**Application No: SSD-83258708**  
**Property: 29 Florida Street, Sylvania**  
**Proposal: Construction of 8 residential flat buildings containing a total of 484 dwellings across two stages (including 159 residential apartments for the purpose of affordable housing)**

Thank you for the opportunity to comment on the State Significant Development (SSD) application (SSD-83258708) for the above residential development including affordable housing at 29 Florida Street, Sylvania.

**Figure 4** – Extract of Level 04 illustrating location of pedestrian ramp (highlighted in yellow) in comparison to balconies.

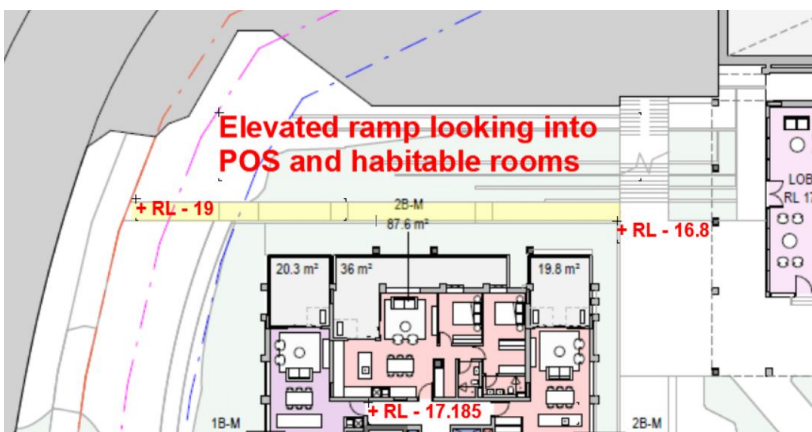
- The elevated ramp adjacent to building 1A results in direct overlooking into the private open space and habitable rooms of the adjoining units, compromising residential privacy and amenity.

**Figure 5** – Extract of Level 04 illustrating location of elevated path (highlighted in yellow) in comparison to building 3A.

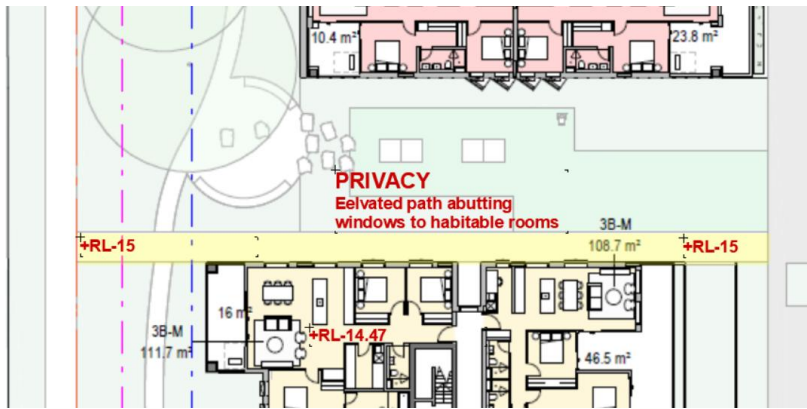
- A foot path elevated above the ground floor level of building 3B is positioned hard up against residential units, compromising the privacy of bedrooms and living areas.

Figure 7 – Extract of internal floor plans.

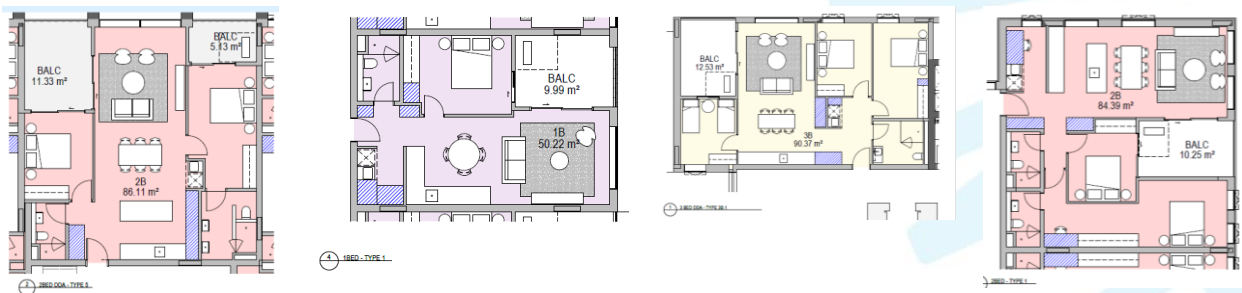
- Several units contain poorly proportioned balconies with narrow frontages, deeply recessed within the building footprint as shown in Figure 7 below. Further refinement of unit layouts is required to address this issue.

Figure 8 – Extract of Building 3A ground floor plan.

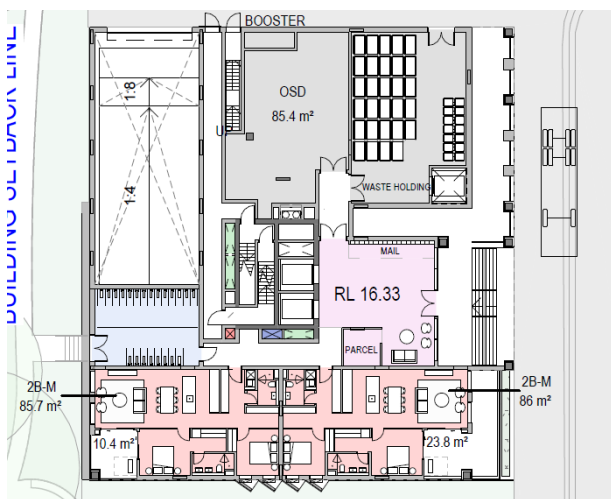
- Several buildings contain awkward, narrow dead-end spaces adjacent to ground floor lobbies which raises safety concerns. The recess provided in the façades contribute to articulation at upper levels, but are poorly resolved at ground floor level, further development is required. Potential for antisocial behaviour should be minimized by increasing the extent of passive surveillance, eliminating narrow dead-end spaces accessible at ground floor level and appropriately locating amenities with the development.

**Figure 10 – Extract of planting strategy.**

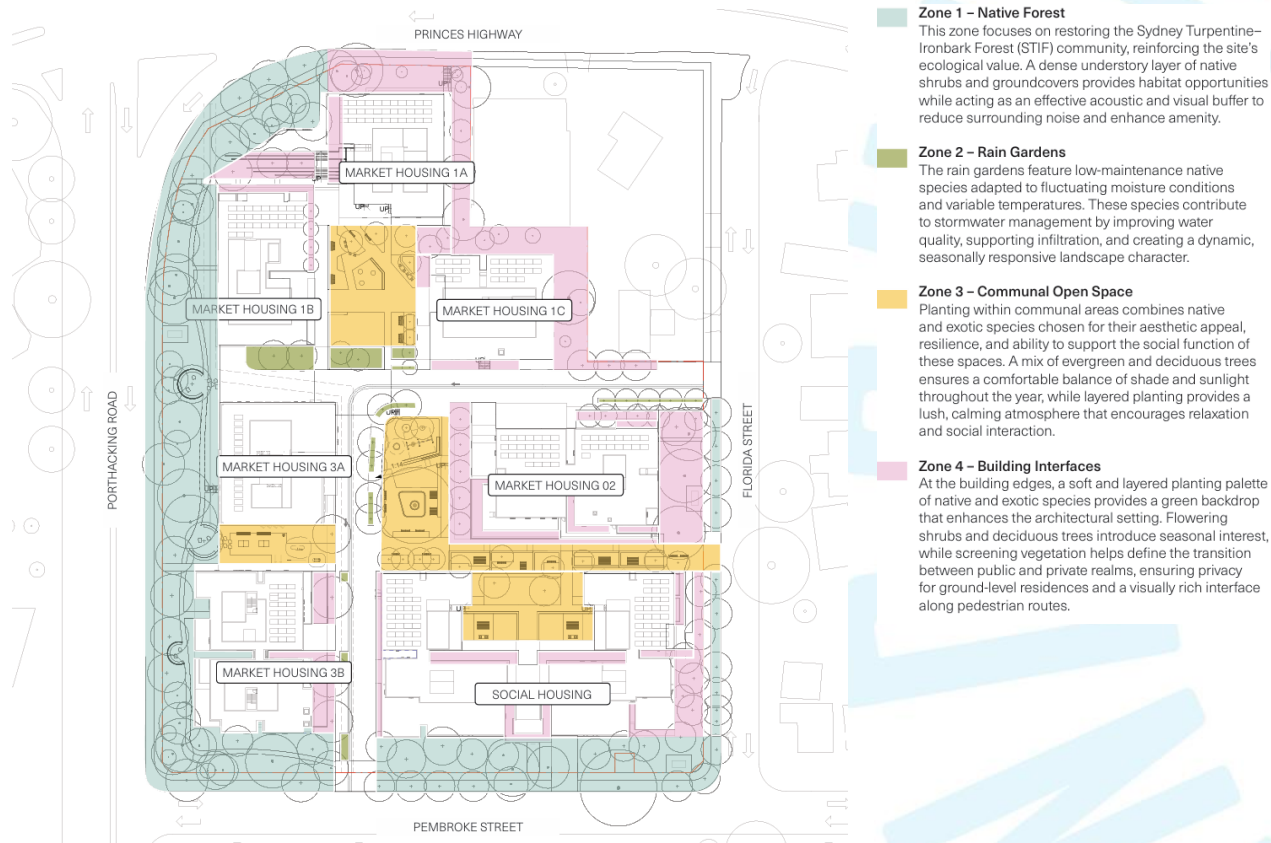
- Zone 1 – Native Forest aims to restore Sydney Turpentine Ironbark Forest vegetation community. Most species are appropriate, however the *Tristaniopsis laurina* (Water Gum) and *Cupaniopsis anacardioides* (Tuckeroo) are not species of this community. Instead, Our preference is to include species such as *Acacia implexa* (Hickory) and *Allocasuarina torulosa* (Forest Oak).

- Zone 2 – Rain Garden aims to provide species that have a high water intake. The species recommended in the report are suitable native species for the area and provide adequate canopy. However, these species are not resilient to high water intake. Therefore, our preference is to include species such as *Melaleuca styphelioides* (Prickly Paperbark) and *Melaleuca quinquenervia* (Broad Leaf Paperbark) which are more suitable to a raingarden setting

- Zone 4 – Building Interfaces aims to provide landscaping around the building edges. Endemic trees should be selected over deciduous trees within this zone as they will provide greater resilience in high density area and offer similar flowering to deciduous species.

**Figure 11** – Extract of Level 04 showing location of waste rooms and loading bay associated with the Social housing building.

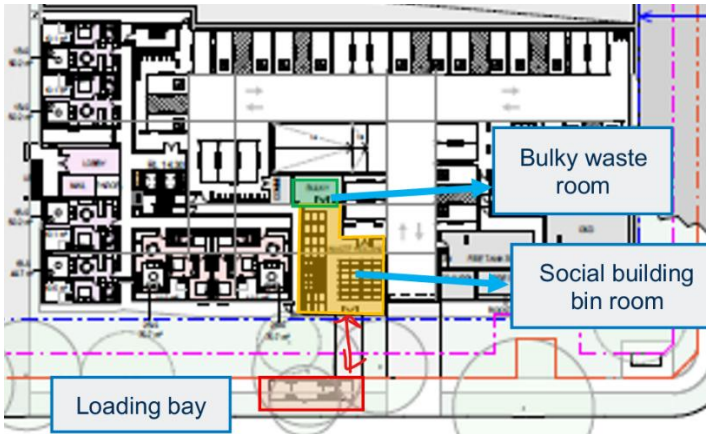
- The distance between the truck and bin rooms needs to be less than 10m to ensure the truck can reverse to the door – the distance seems to be greater and is not supported.
- The driveway proposed to the waste room fronting Pembroke Street is not long enough to accommodate a parked waste truck. The driveway is required to be lengthened to ensure the public footpath is not obstructed when the truck is parked.
- The bulky waste room is not large enough to accommodate the number of residents within this building. The bulky waste room also needs to be located at the kerbside with a double door or roller door for ease of access.

**Figure 12** – Extract of Level 04 showing location of waste rooms and loading bay associated with Buildings 1C and 2.

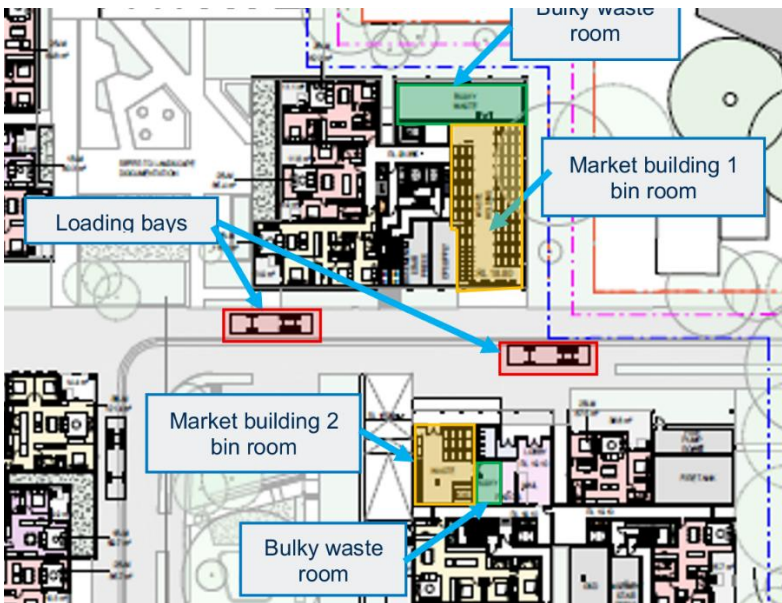
- The distance between the loading bay and the bin room doors would be greater than 10m and is not supported.
- The bulky waste rooms are considered a suitable size to service the residents. However, these rooms must be located at the kerbside with a double door or roller door to assist waste collection.
- The loading bay is located too far from the bin rooms and all bulky waste rooms

**Figure 13** – Extract of Level 04 showing location of waste rooms and loading bay associated with Building 3A.

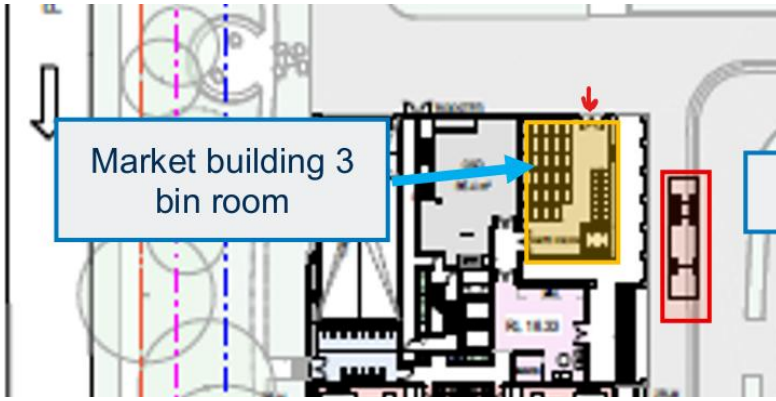
- The distance between the loading bay and the bin room doors would be greater than 10m is not supported. It seems the bin room doors (which need to be double doors or roller doors) are located along the northern façade and the loading bay is located on the eastern façade of Building 3A. The loading bay is required to be relocated along the northern façade of the building to ensure the distance is less than 10m to the bin room doors.
- Amended plans need to provide a bulky waste room and need to be located at the kerbside to assist with waste removal.
